PART 21 IDENTIFICATION NO. 80-233-001 COMPANY NAME Westinghouse

NS-TMA-2264

No.: NSD-TB-80-9  
Date: 5/13/80

Subject W-2 Switches (with spring return to neutral)  
System(s) Electrical Control S.O.(s) 385  
Affected Plants All Sites  
References Technical Bulletin NSD-TB-73-26

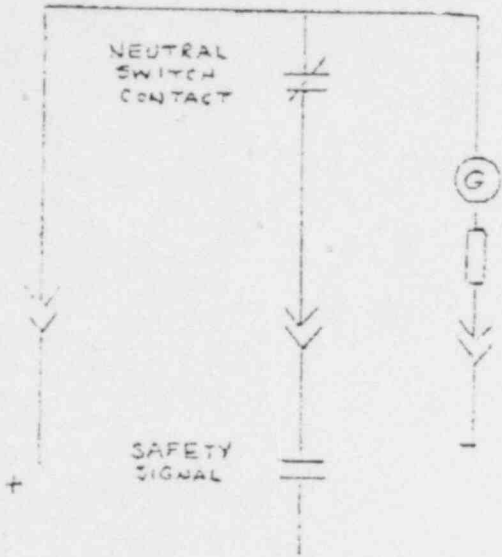
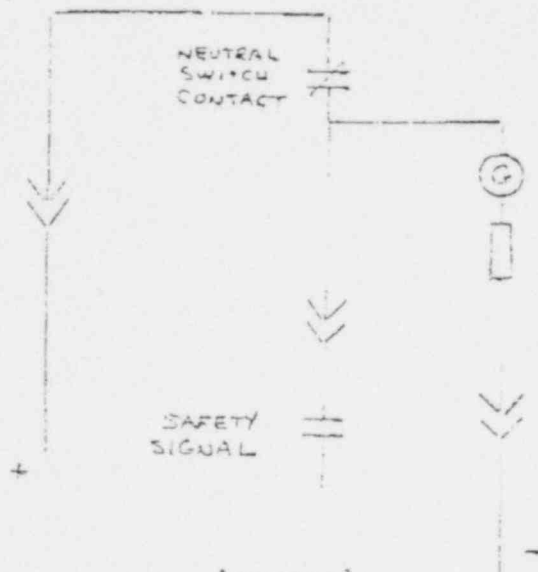
Furthermore, these tests should be repeated following each subsequent use (removal from the neutral position) of the switch. Testing should be done either at normal operating voltage at the contacts, or at least 24 volts DC. As an alternative to repetitive continuity checks after switch operation, wiring to the existing breaker "green light" indicator may be put in series with the neutral position safety-related switch contacts. (See sketch). Plant operators should then be aware that "green light" indication may no longer exist during the lock-out (pull-out) position.

Green light indication will now confirm closure of the safety-related switch contacts in the neutral position. This "green light" indication should be checked after each switch operation.

EXISTING (TYPICAL)

PROPOSED (TYPICAL)
